Work Order ID 113217

Item Name: Bearing

| DATE 04.02.17 | | TITLE BRACKET ASSEMBLY | SCALE 1:1 |

| DRAWING NO. D3183 | TITLE BRACKET ASSEMBLY | REV.C1 | DART AEROSPACE LTD ENGINEERING ORDER | | D.E.O. NO. D3183-C1-1 | SHEET NO. SHEET 1 OF 1 | SCALE NTS |

D3183-5 BEARING

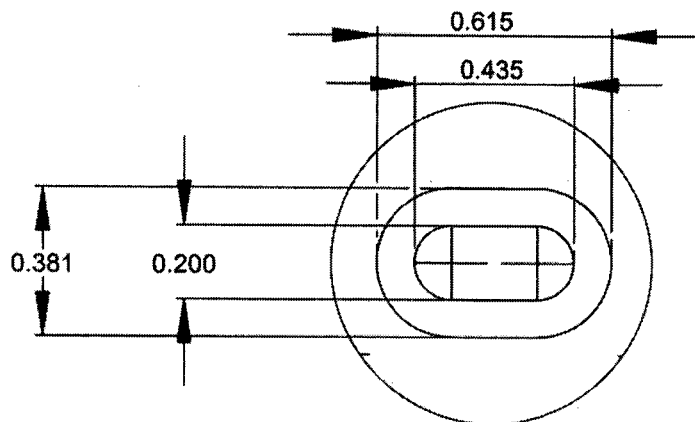
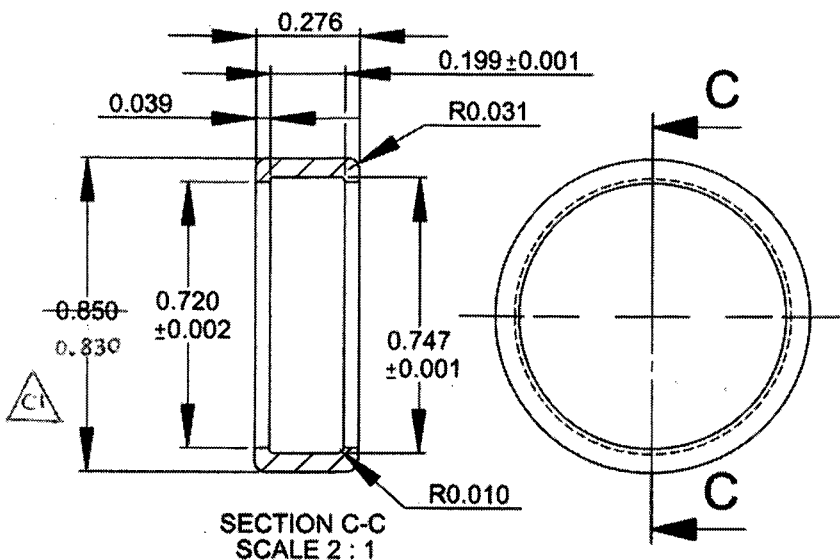
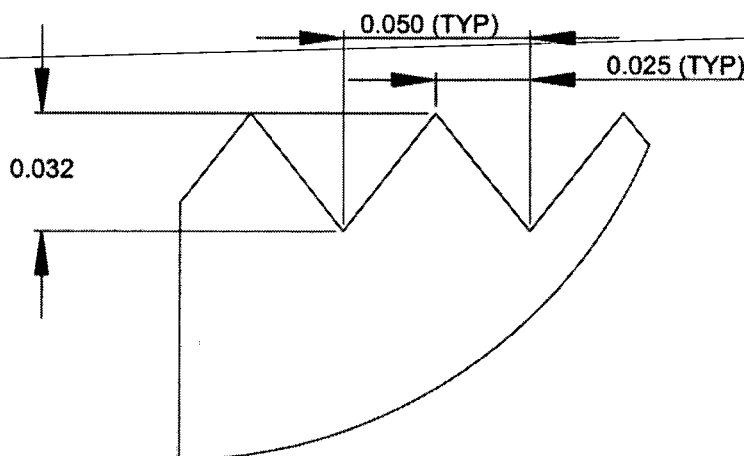
ADD POSSIBLE SUPPLIER: KML P/N 6800-ZZ

BASIC LOAD RATING REQUIREMENT: Cr = 1720 N (386 lb) MIN [DYNAMIC]
Cor = 840 N (188 lb) MIN [STATIC]
